Year 2 Monitoring Report
FINAL
Greenbrier Stream Mitigation Project

Yadkin County, North Carolina

NCDEQ Contract No. 7616
DMS ID No. 100086
USACE Action ID No. SAW-2018-01755
NCDWR ID: 20181272
Yadkin River Basin
HUC 03040101

**RE: Response to Draft MY2 Monitoring Report Comments dated November 30, 2021
Greenbrier Stream Mitigation Site
Yadkin River Basin – CU# 03040101 - Yadkin County, North Carolina
NCDMS Project # 100086, Contract # 7616**

GREENBRIER STREAM RESTORATION SITE
 CURRENT CONDITION PLAN VIEW: OVERVIEW MAP
 MY2: 2021

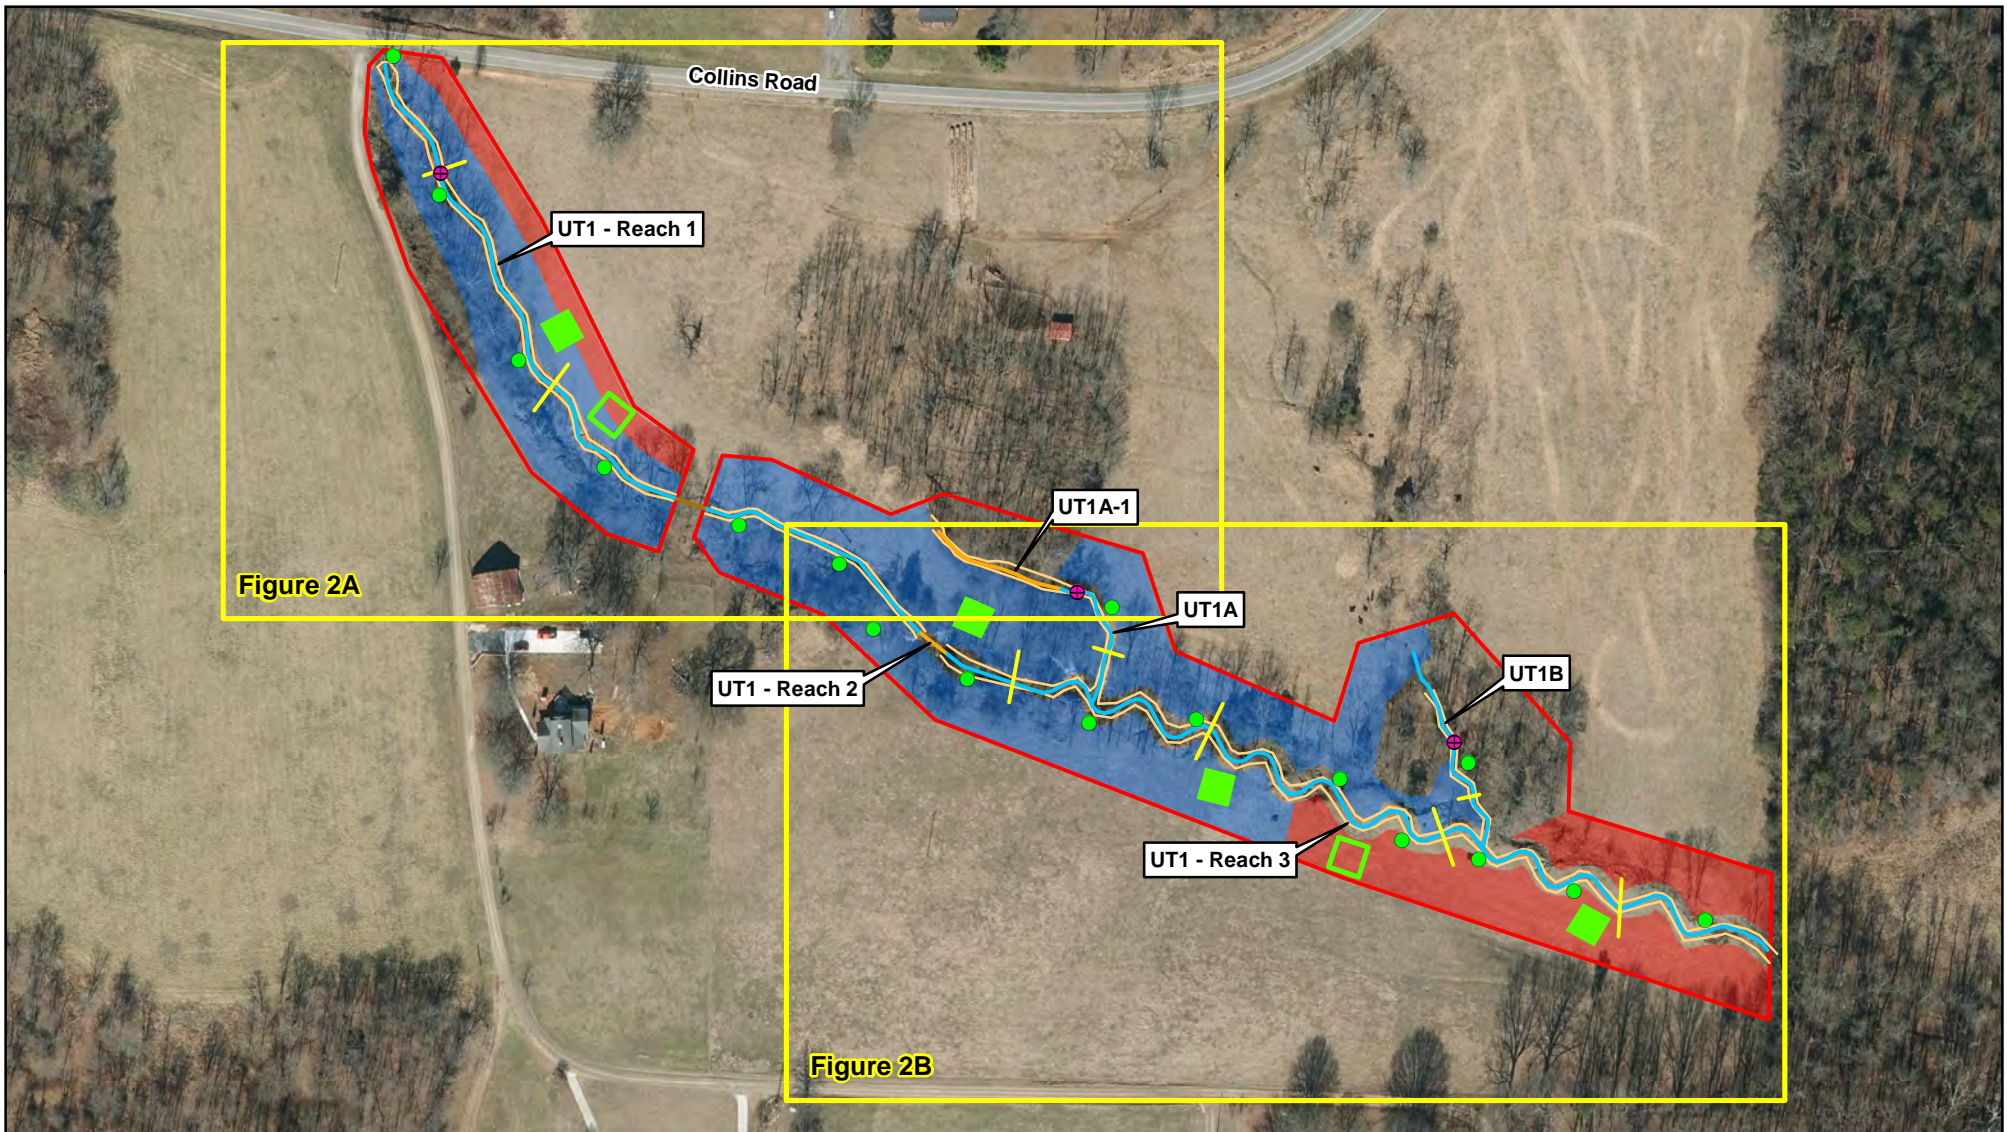
- **A discussion regarding plot height has been added to Section 2.2.1.**
- **CCPV Maps:** *The overview map is incorrectly labeled as MY0: 2020. The aerial orthoimagery is from 2018. Please update the maps if more recent aerial imagery is available. Please QA/QC the CCPV maps and update as necessary.*

- **Dates have been included for all project photo points.**
- **Report Text and Appendix B:** In the revised report (Appendix B), please provide a planting map and species list from the March 2021 supplemental planting effort reported in Section 2.2.1 Vegetation Monitoring Data. Please reference the planting map and species list in the report text. Please also report what percentage of the initial planted area was supplementally planted in MY2(2021). The supplemental planting area should also be included on the MY2 CCPV maps.

- *Please include a feature representing the supplemental planting areas and display this in the CCPV map/s.*
 - **The shapefile Greenbrier_2021_Planting_Zones has been added to the electronic submission CCPV folder. This shapefile has been included in the CCPV.**

- **The date on the overview maps has been updated. The 2018 aerial orthoimagery shown in the CCPV is the latest aerial image available for the project area. EPR will update these images in future monitoring years as new imagery becomes available.**

- **A planting species list has been included in Appendix B, and the planted areas are now shown on the CCPV. The map and species list are referenced in section 2.2.1 Vegetation Monitoring Data. The approximate percentage of the original planted area has also been included in this section.**
